Amendments to the Drawings:

Appln. No.: 09/932,647

Amndt. dated July 27, 2005

Reply to Office Action of April 5, 2005

FIG.5a

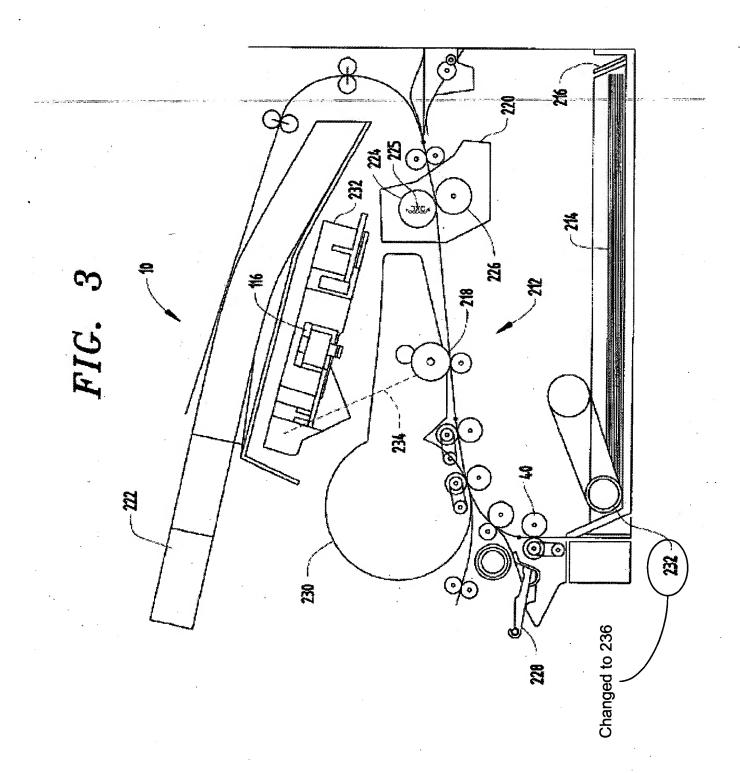
amended) has been changed to reference numeral 236. In FIG. 5, the use of reference

numeral 300 is redundant. To clarify, reference numeral 300, referring to "Turn Mirror

Off" has been changed to reference numeral 306. See published application paragraphs

been amended to reference numeral 236. See amended paragraph 0027. In FIG. 5a

reference numeral 300 referring to "Turn Mirror Off" has been amended and is now

reference numeral 306. See paragraphs 0052-0053. The reference numeral changes have
